Product Change Notification

Date Issued :	May 25, 2022	PCN Number :	512018
Reason for Change :	Capacity change or tool replacement		
Description of Change :	This notification is to inform you about set of tooling is being added to meet the current and future demands of this product referenced below. There will be no changes in fit, form or function from additional tooling when compared to the existing tooling.		
Reason for Short Notice :	Capacity Increase		
Assessment of Change :	First Article Inspection		
Planned Implementation Date :	August 25, 2022		
Sample Availability Date:	June 01, 2022		
Internal Molex Qualification Date :	June 01, 2022		
Last date to request Samples by Customer :	June 30, 2022		
Traceability Code Markings / Date :	Date code

Series# 45750

Affected Product Photos

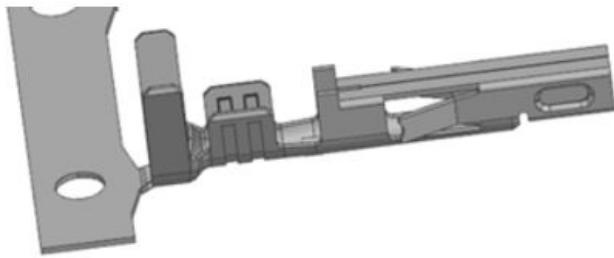
- New capacity increase for Mini-Fit plus Crimping terminal H.C.S series 45750 in Shanghai, and the supplier of the metal material change to China Local.
- Customers will be supplied from Lincoln or Shanghai production facilities going forward.
- Product Impact: No impact to fit, form or function
- Part number Impact as attachment.
- Qualification Reports and samples available upon request.
